Section 5-1400 Landscaping - Buffer Yards, Screening, Parking, and Landscape Plans

Buffer Yard Location Example

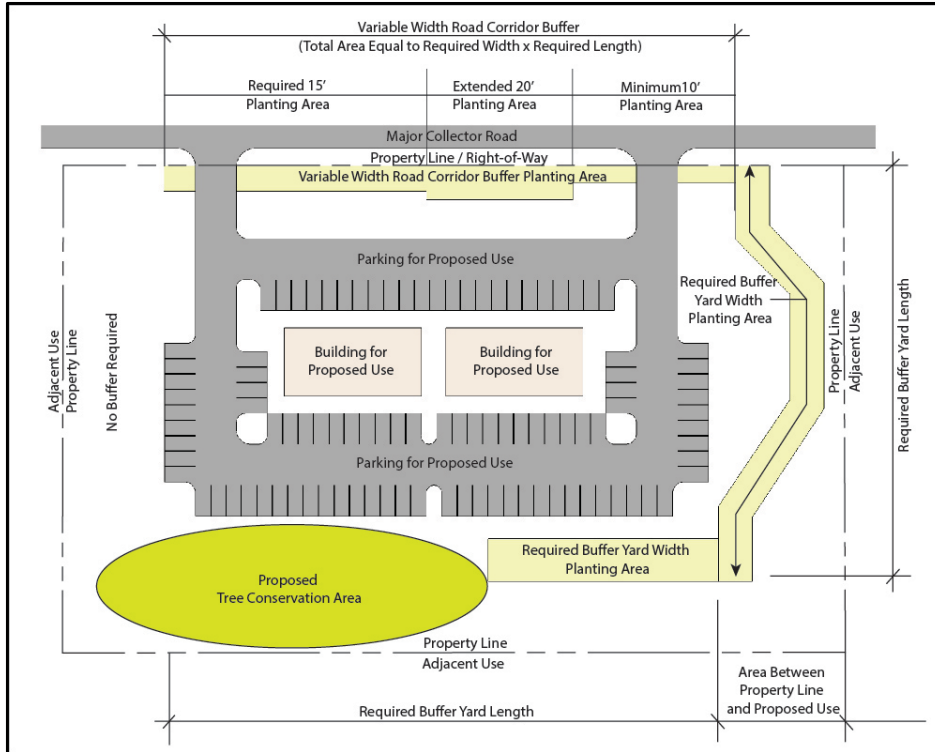
Commented [EJ39]: NRT: Change "Proposed Tree Save Area" to "Tree Conservation Area"

Commented [EJ40R39]: RESPONSE: Revised as requested.

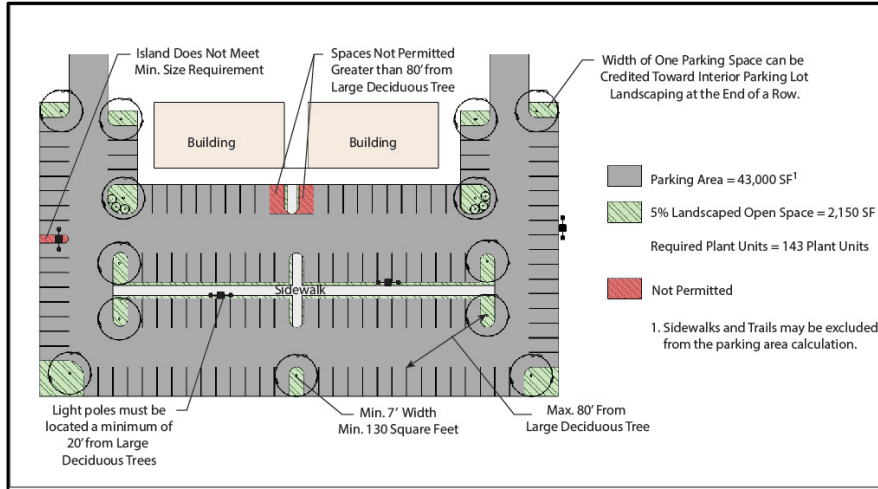
Commented [EJ69]: NRT: Revise graphic per previous comments.

Commented [EJ70R69]: RESPONSE: Graphic has been revised.
